UTAH DEPARTMENT OF TRANSPORTATION

SUBJECT: Standards Committee Meeting Minutes and Next Meeting

Standards Committee Meeting

Minutes of the February 24, 2005 meeting:

DEER RAMP DETAIL

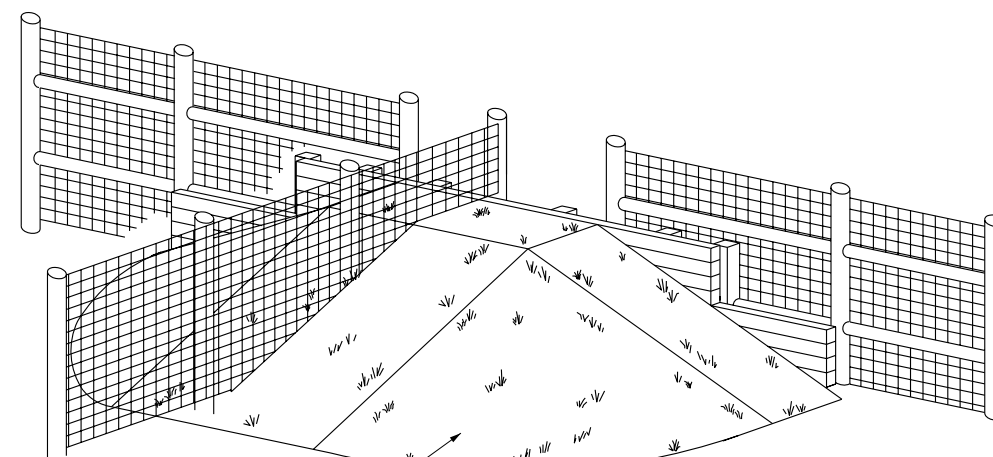
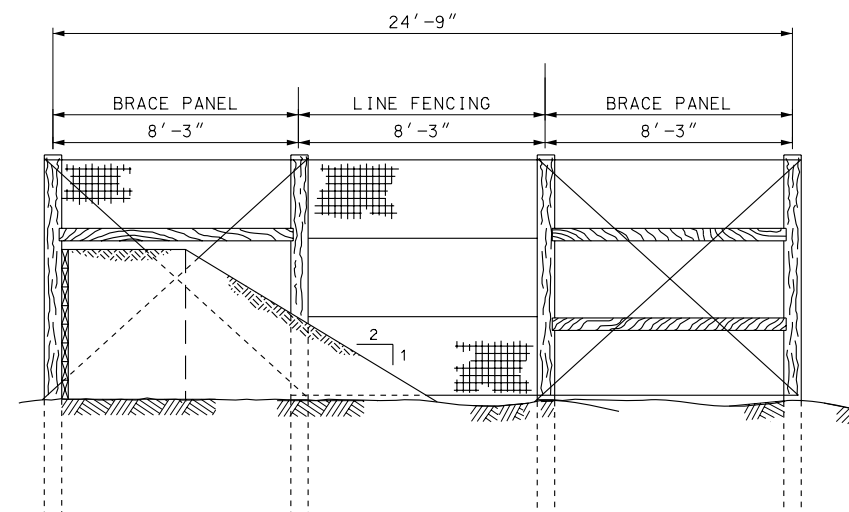
- Commenting on the drawings Tim said he didn't think there was enough information to construct the ramps. Michelle said she didn't want to add another sheet so she tried to consolidate space. She said if you draw a line down the center of the page for FG 4B, the left side is for the high migratory area and the right side for the typical. She said they could enlarge the typical and put it on its own page. Tim said the title on both drawings is the same for two different things. He said on FG 4A there are two different tags for the same thing on the three ramps. Tim didn't think there was anything wrong of the details, just the callout names. Michelle asked if the confusion would be eliminated if they were all called deer escape ramps. Boyd suggested including "High Migratory" in the title of the FG 4A drawing.

- Tim commented on the wording of the note below the isometric view on FG 4B. He said there is nothing that shows where the drift fence goes. Michelle said on the typical there is a drift fence, but not on the high migratory one. Michelle said she would remove the note from the high migratory portion of the drawing. Tim said the wording just needed to be worked out. Michelle said having another sheet might help with some of the confusion.

- Boyd said the 3 foot 10-inch embedment part of the post needed to line up properly.
- Comments indicated that a "High Migratory" section needed to be added to the specification.

- Karl commented about the payment of topsoil, seed, and mulch. He thought it should be included instead of paying by the acre. Michelle said she would take the "required" off the detail and work out the wording.

AT 4

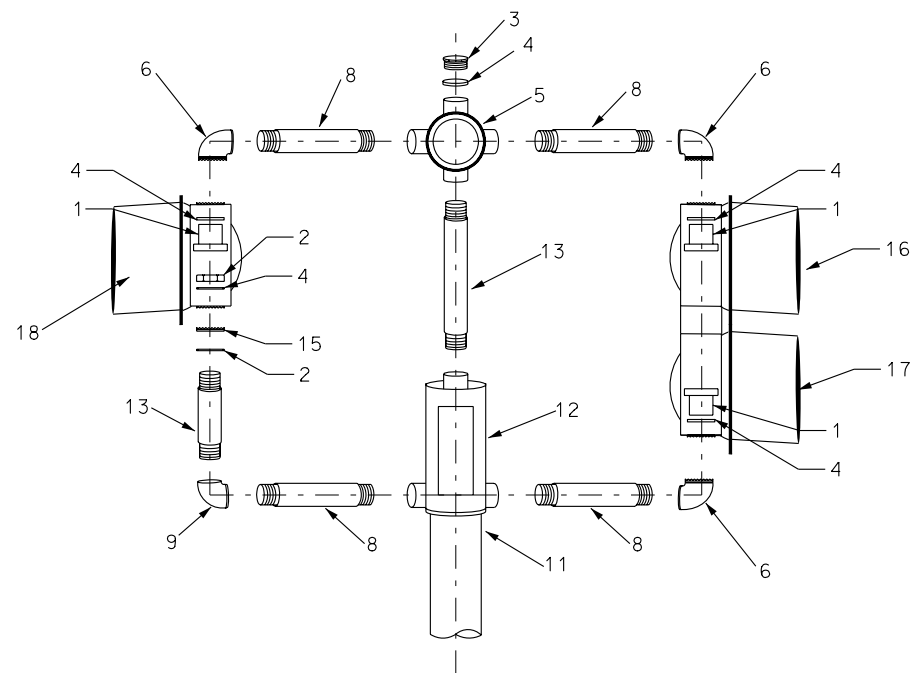
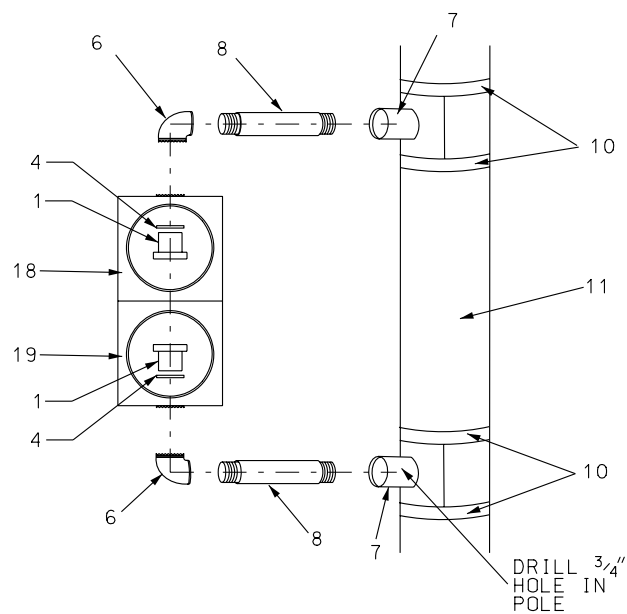
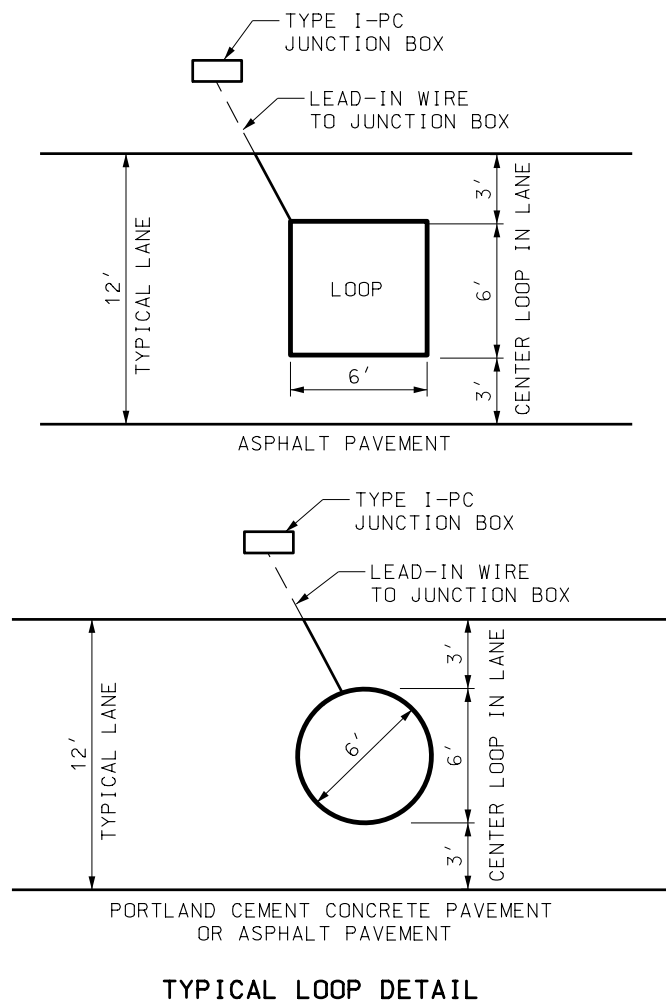
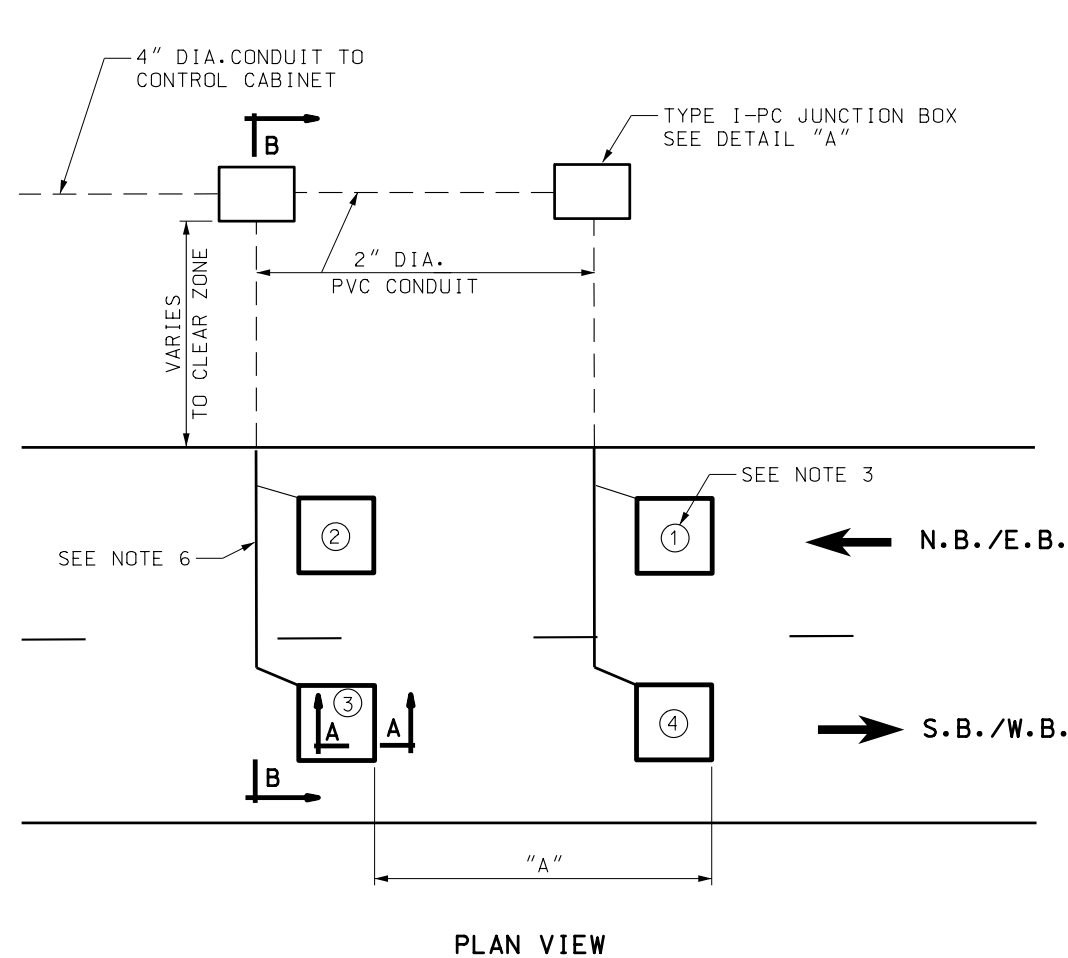
- Referring to AT 4 Barry said the note section lists several items as not used with other items added. He asked if the numbers could be redone so that there were no “not used” items. Sam said he hadn’t caught that. Sam added that there are several other issues with this drawing. He said the items couldn’t be build the way it is designed and he would like to resubmit the drawing for approval at the next meeting. There was consensus to bring the drawing back.

Standard Drawing AT 4 - Typical Ramp Meter Signal Head Mounting details, published January 2005 had errors and needed additional details.

1. 04/28/05 S.S. UPDATED AND REARRANGED DETAILS

TRAFFIC COUNTING
LOOP DETECTOR
DETAILS

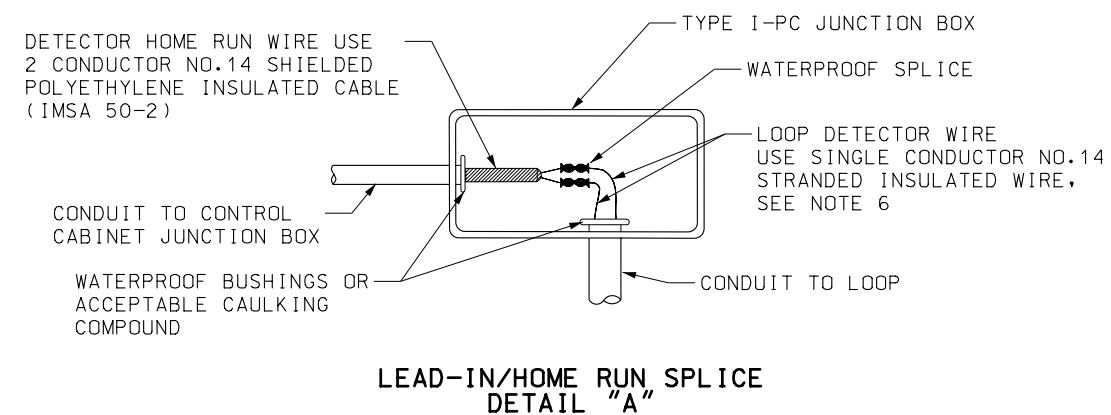
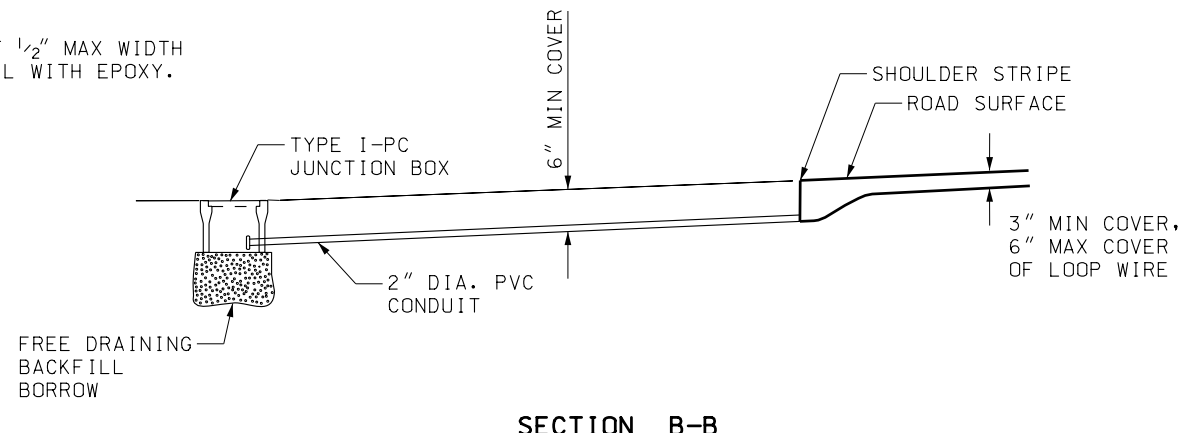
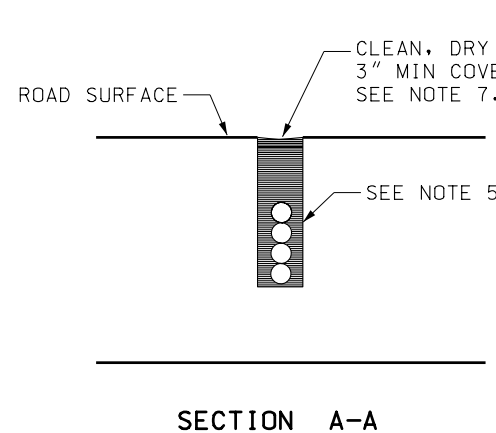
- Bob pointed out the SL 12 was on the list of drawings. Jim asked if anyone had any comments on SL 12.
- Sam said table 1 was added, as was a dimension in the top left of the drawing. He said they have found there are differences in the way the loop spacing is done. He discussed the differences between the traffic counting and traffic monitor loops. He said the ATMS requirements are different from the requirements of Gary Kuhl's group in Planning.

Standard Drawing SL 12 – Traffic Counting Loop Detectors Details has been revised to add loop spacing requirements for high-speed traffic monitoring. Whereas 16 foot loop spacing is acceptable for volume counting, 21 foot spacing is more appropriate for traffic monitoring, such as speed and occupancy. The Traffic Statistics contact phone number has also been removed, since the contractor should be coordinating construction directly with the Resident Engineer.

TABLE 1. LOOP SPACING

LOOP TYPE	"A"
TRAFFIC COUNTING LOOP FOR PERMANENT COUNT STATIONS	16' ± 1"
TRAFFIC MONITORING STATION FOR ATMS	21' ± 1"

VIDEO DETECTION CAMERA

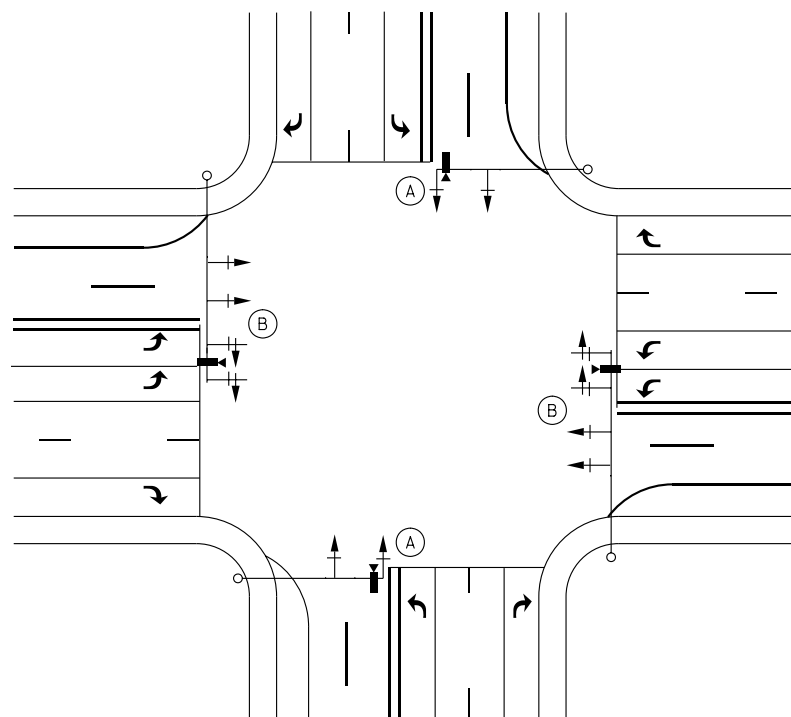
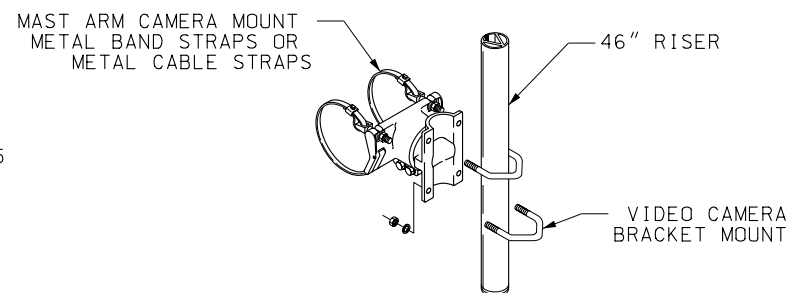
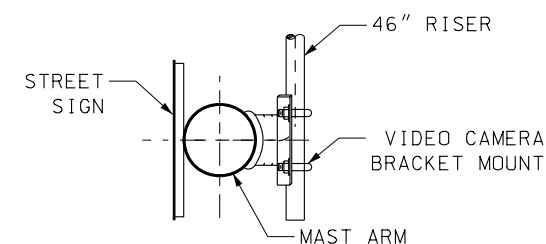
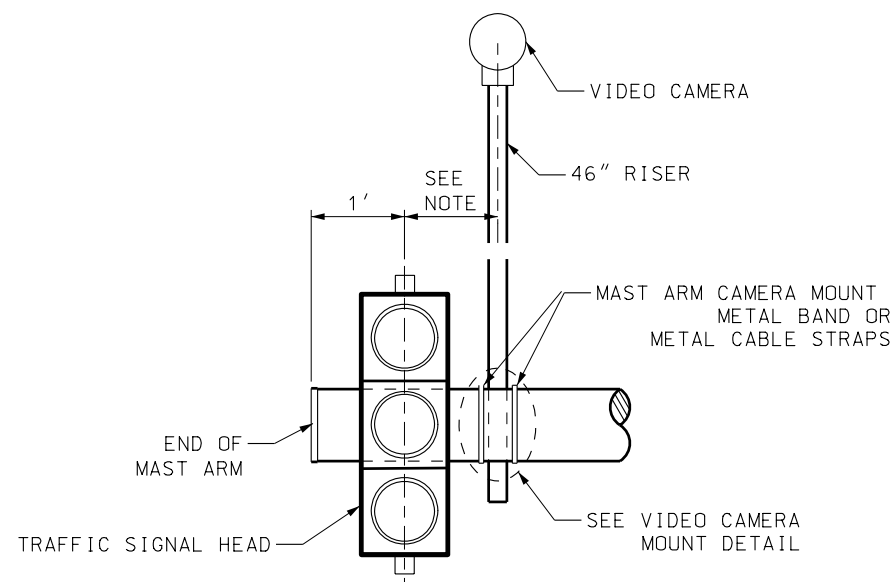
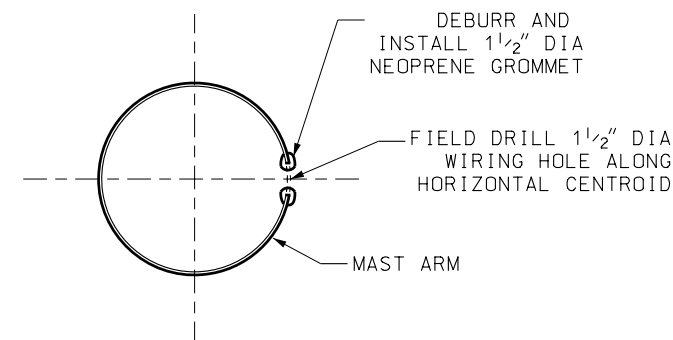
Change note 1 to read "See Std Dwg SL 1A and SL 1B for signal pole and mast arm notes and details."
